City of Carlisle, Iowa
Planning and Zoning Commission
Regular Meeting
July 18, 2022

RE: Ridgewood Valley Plat 1 – Construction Drawing Review
PROJECT #7023.057

RE: Ridgewood Valley Plat 1 – Final Plat Review
PROJECT #7023.058

MARK	REVISION	DATE	BY
	Checked By: BKC	Scale: 1" = 200'	
	Engineer: M.S.	T-R-S: 77N-23W-16	
	Technician: M.S.	Date: 07-01-2022	
		Project No: 121.0728.01	Sheet C200

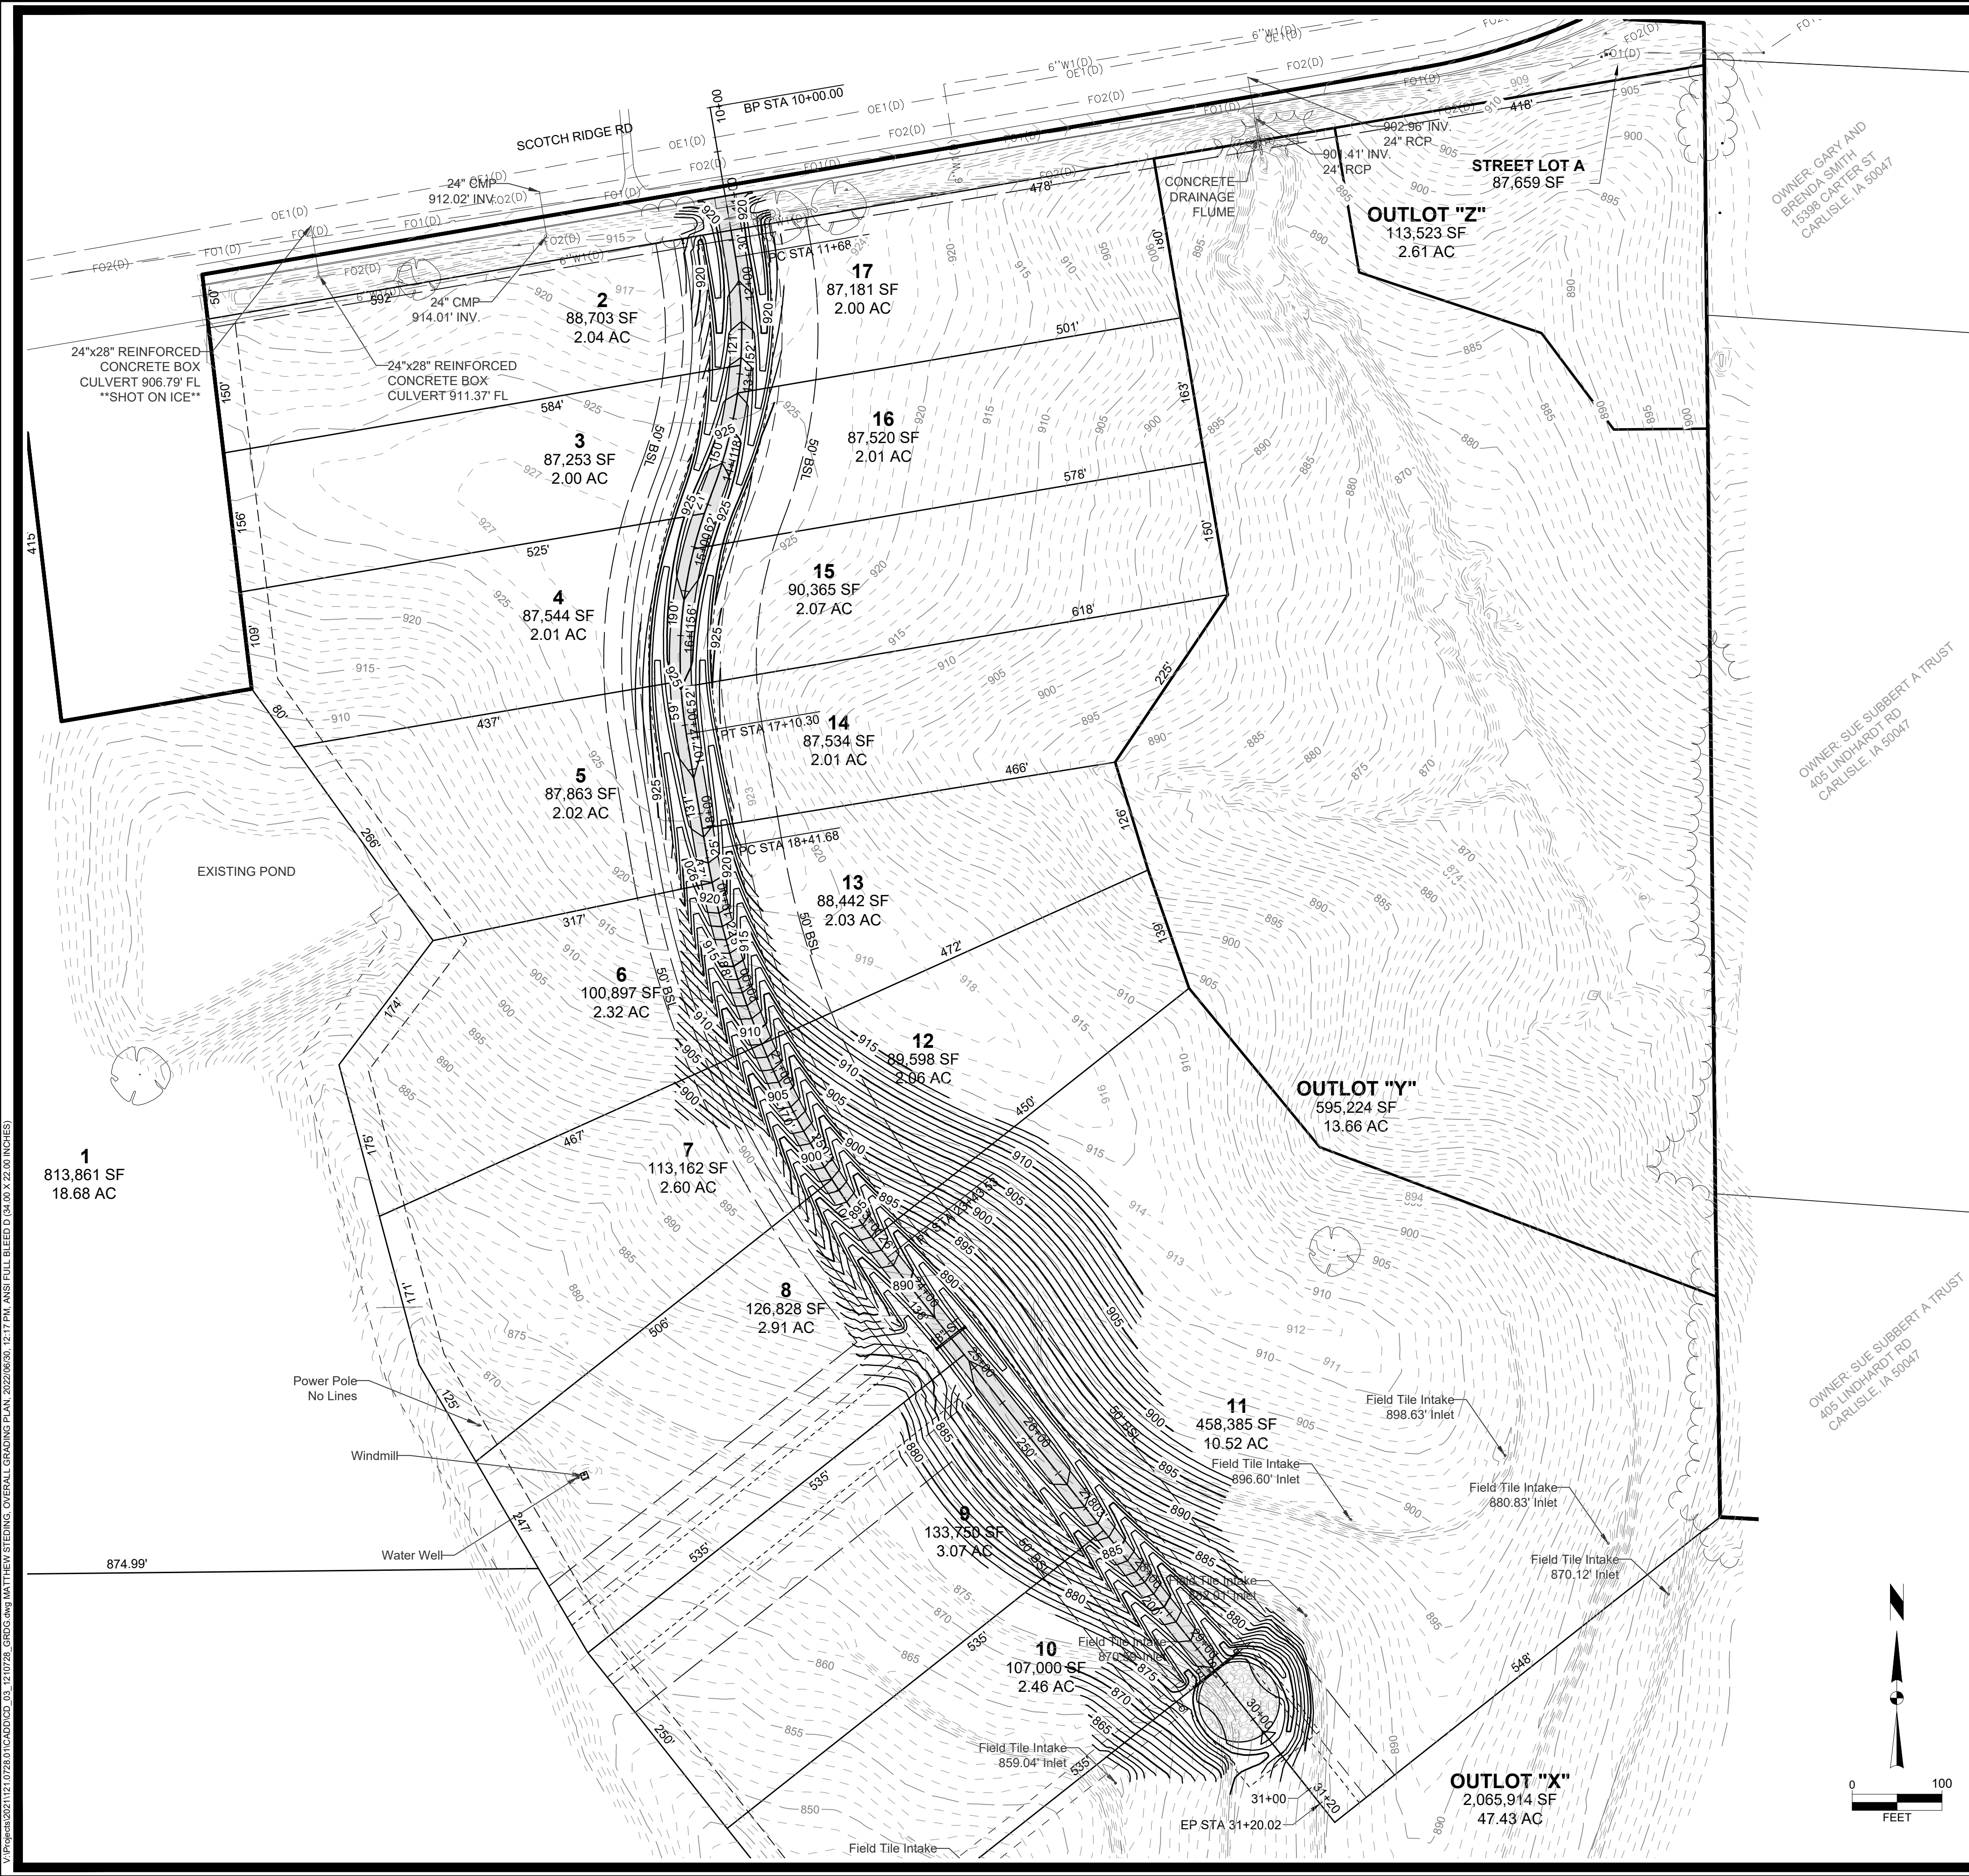
2. The Construction Drawings and Final Plat are being submitted concurrently.
3. Sheet C200 states that “Street Lights, Sidewalks and Trails shall be the responsibility of the individual lot owners if required upon the annexation into the city of Carlisle”. Therefore, a street lighting plan, trail plan and/or sidewalk plan is not provided at this time.

NORTH GRADING PLAN

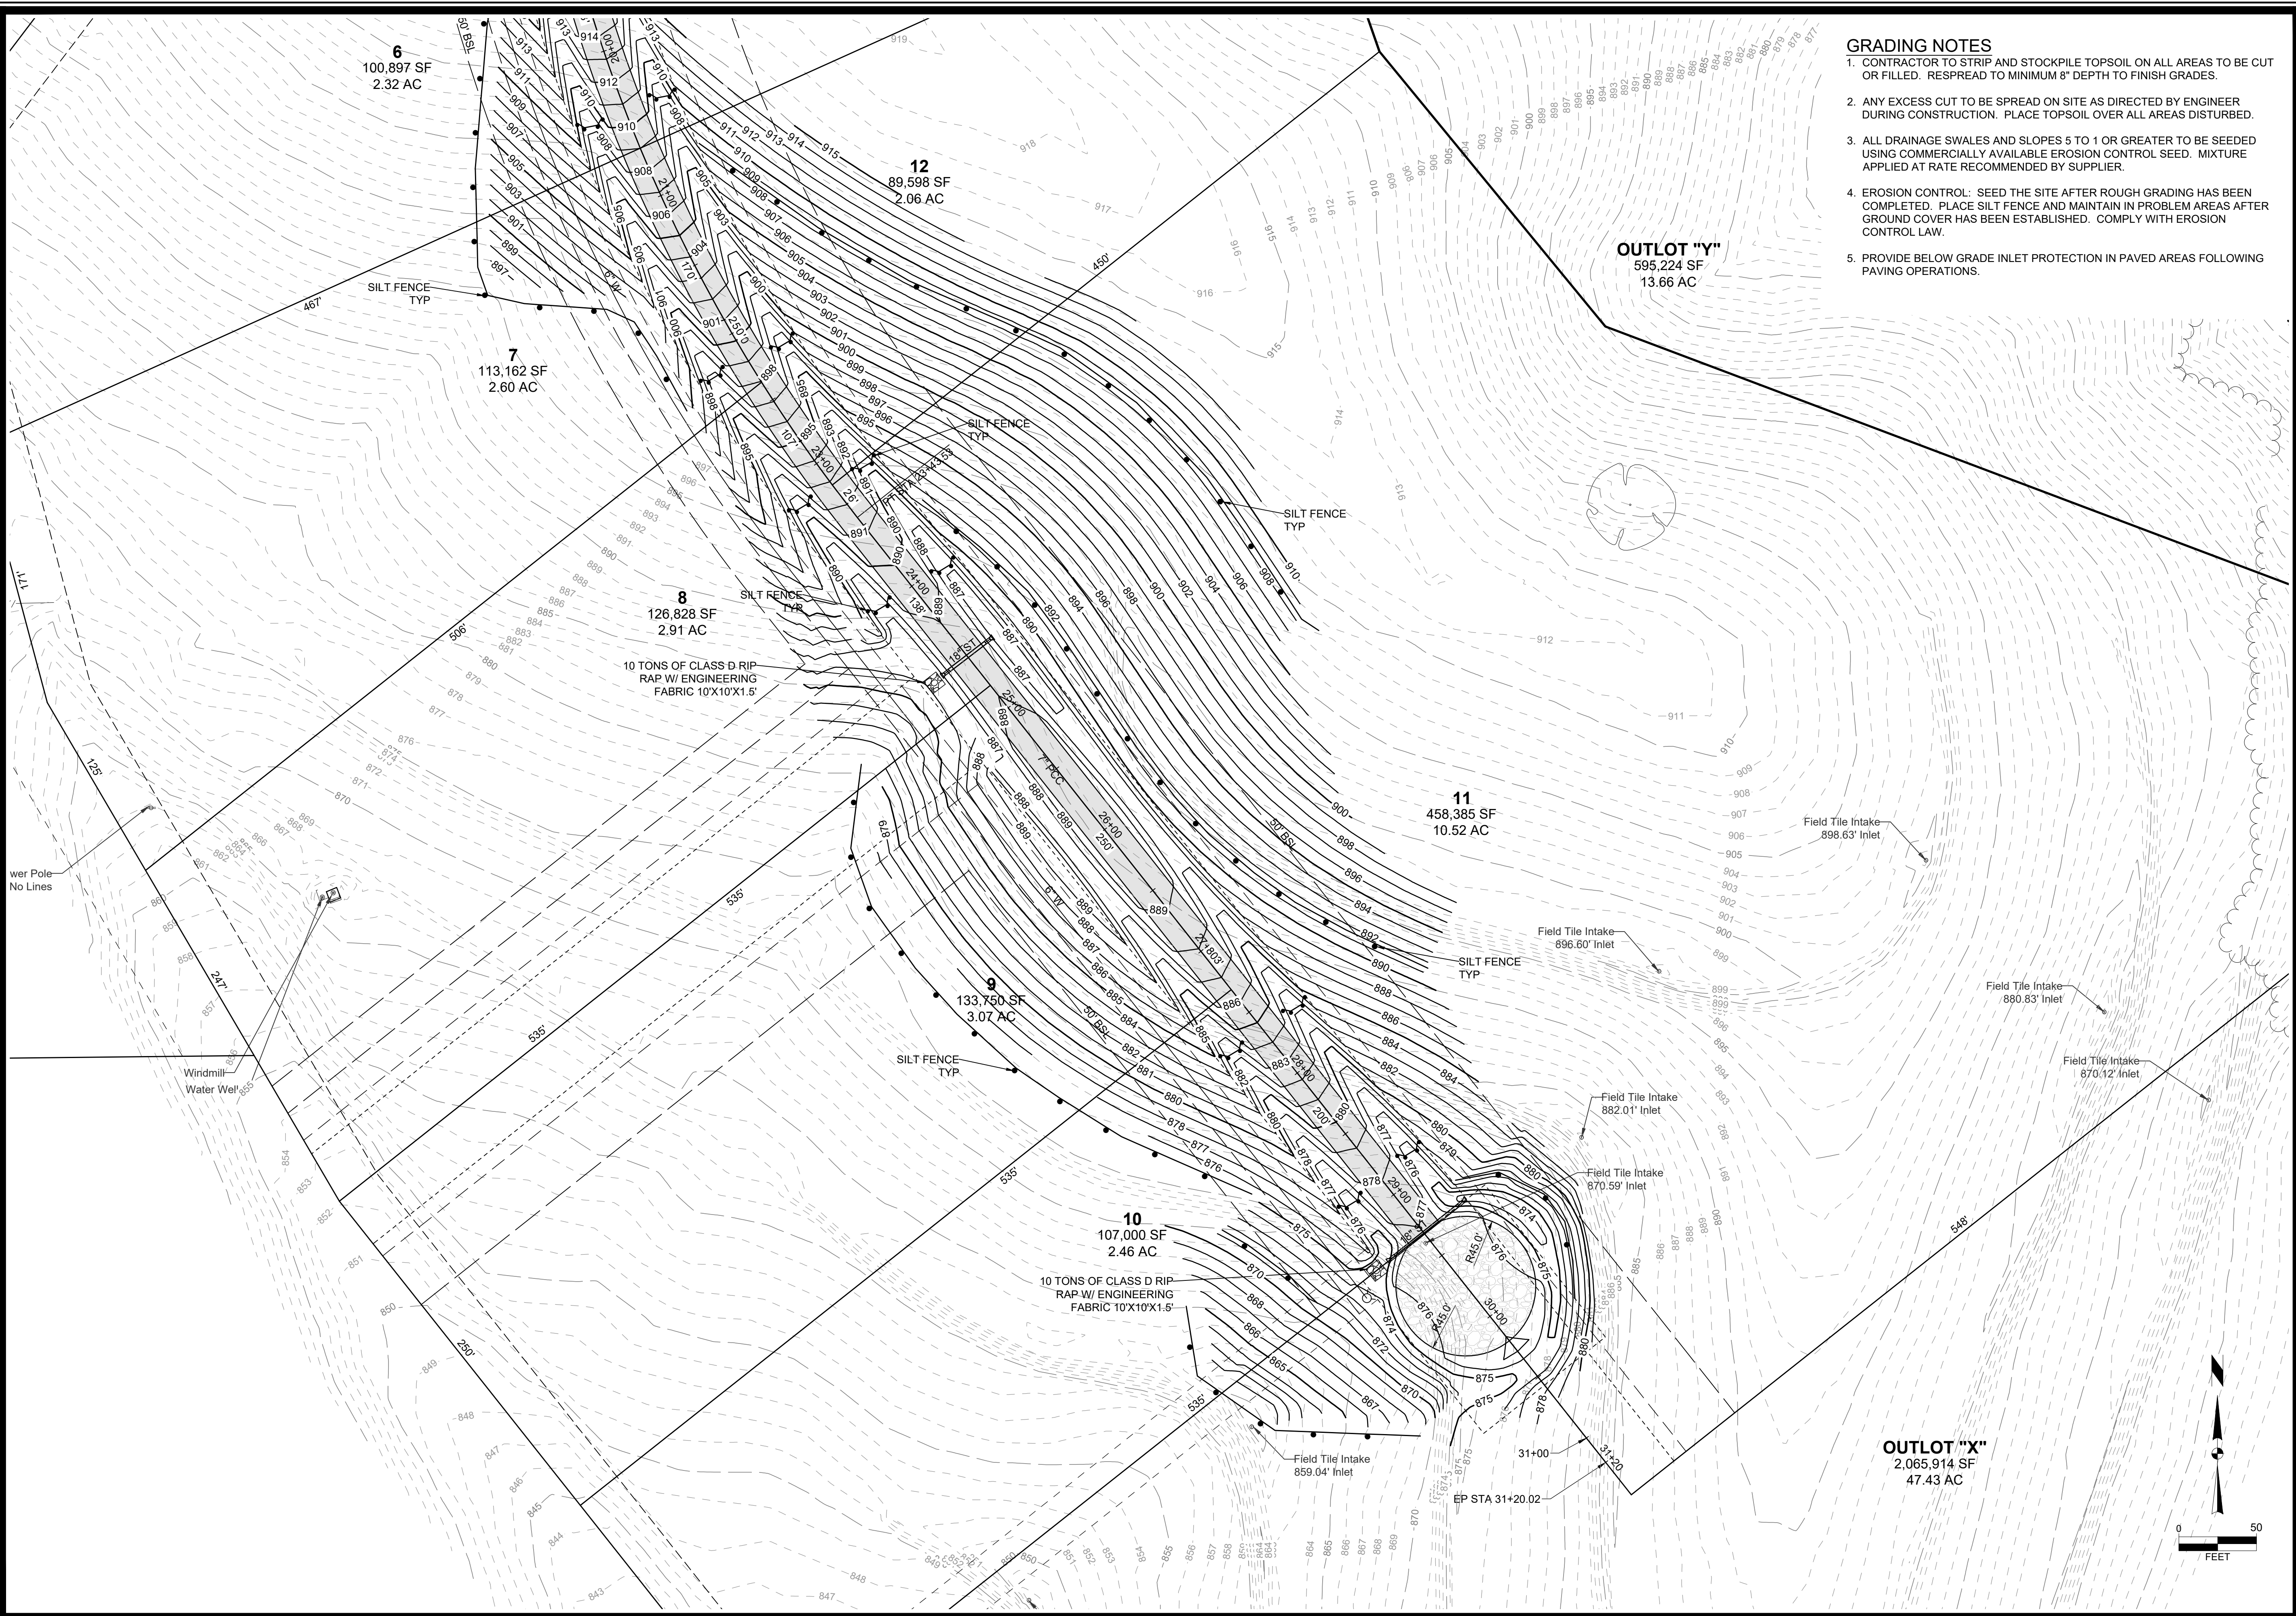
7. Please label the typical longitudinal slope for the ditches on each side of the roadway. The Typical Cross Section states that the longitudinal slope is a minimum of 1%, however, our experience is that slopes under 1.5% will require subdrain or will be prone to wet conditions. Please review whether it will be possible to achieve a minimum of 1.5% longitudinal slope in the ditch areas.
8. Please provide a minimum of a 6-ft earthen or granular shoulder outside of the pavement at the returns for the entrance to the subdivision.

SOUTH GRADING PLAN

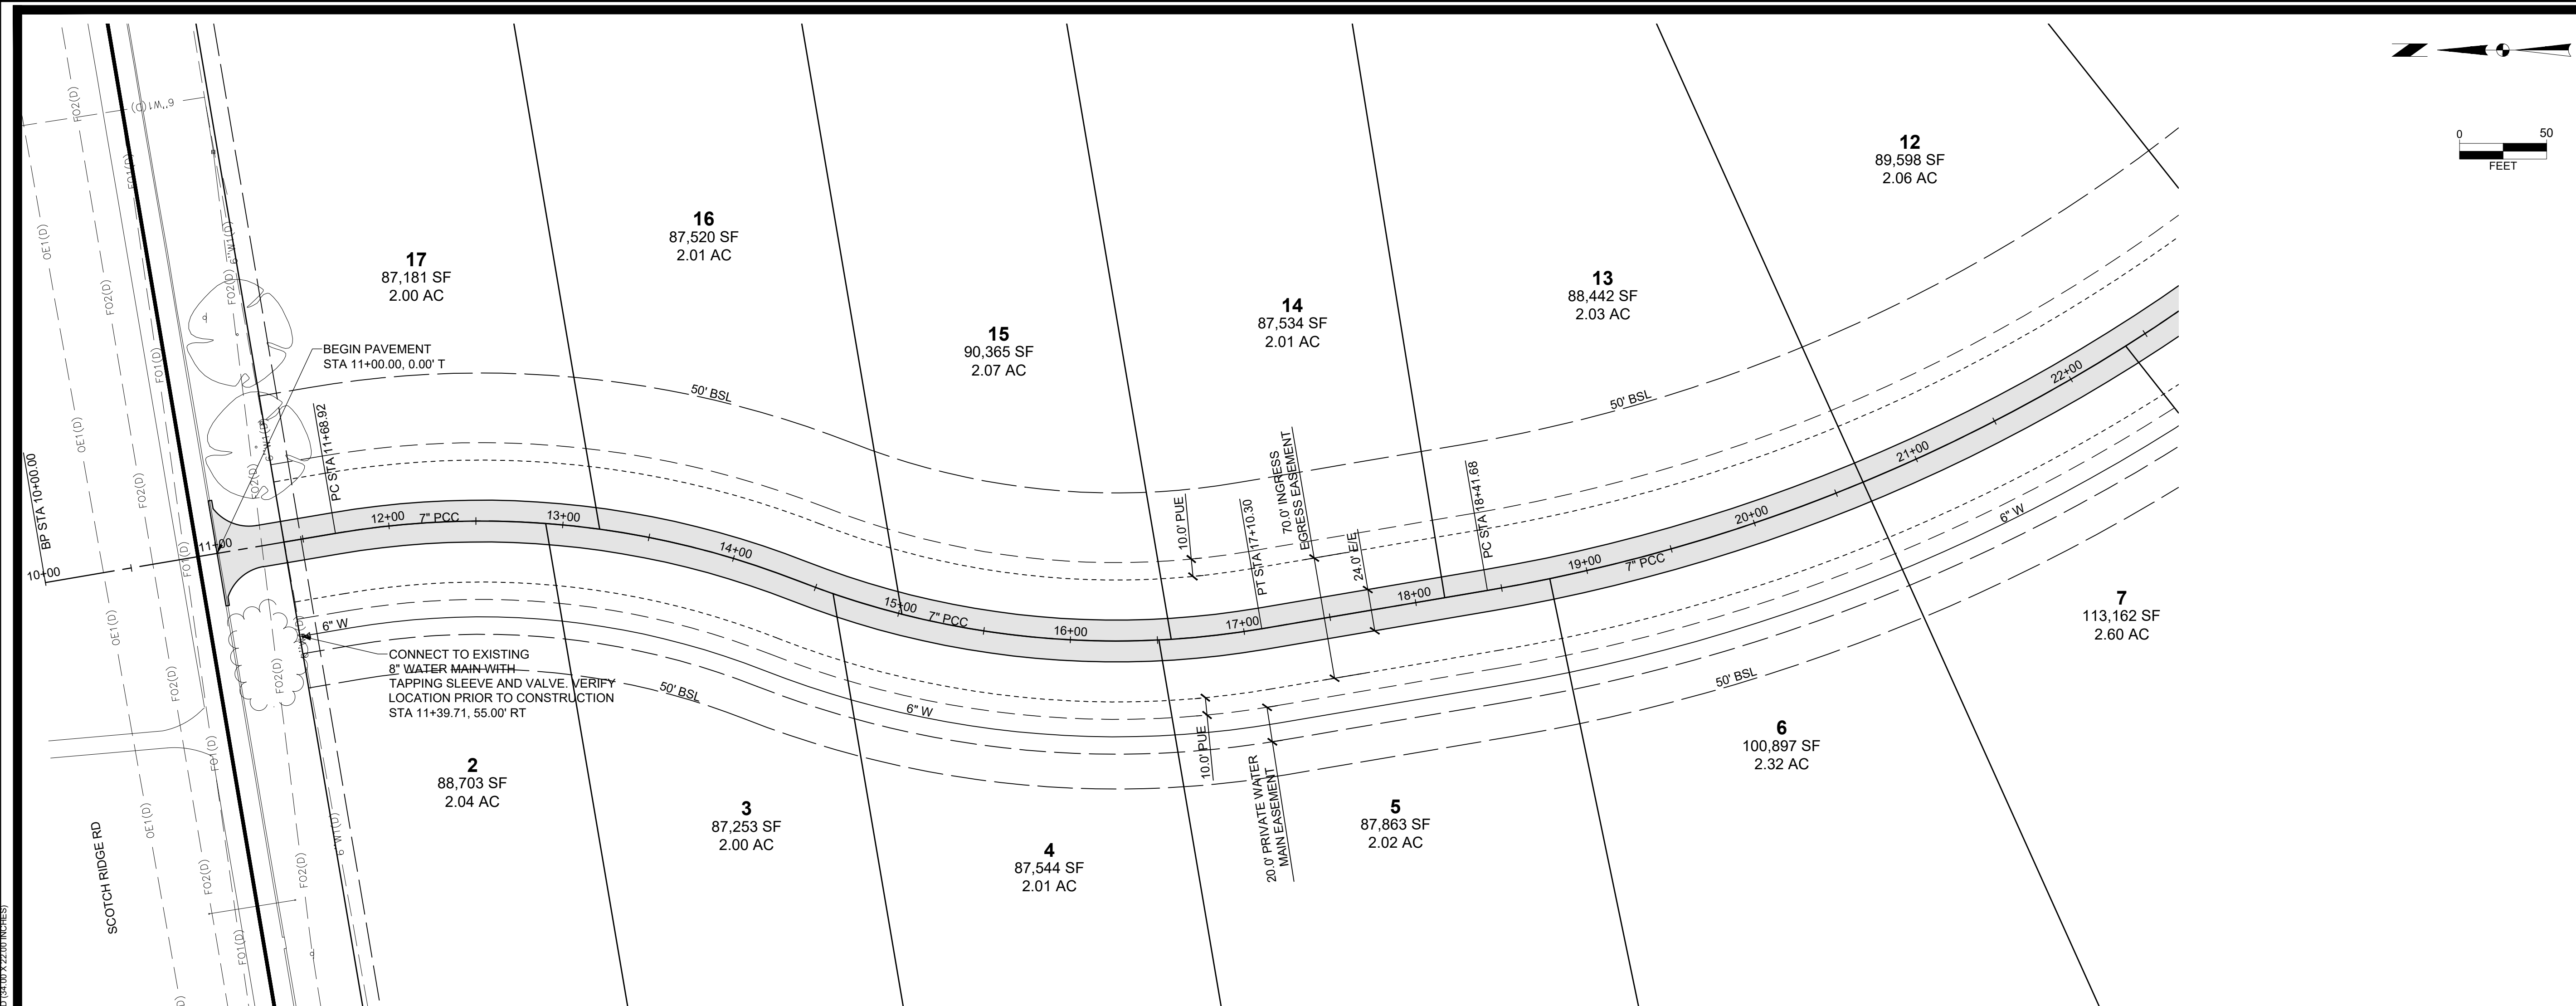
9. Please clarify the typical grading backslopes/foreslopes on this sheet. The Typical Cross Section is not representative of how areas outside of the
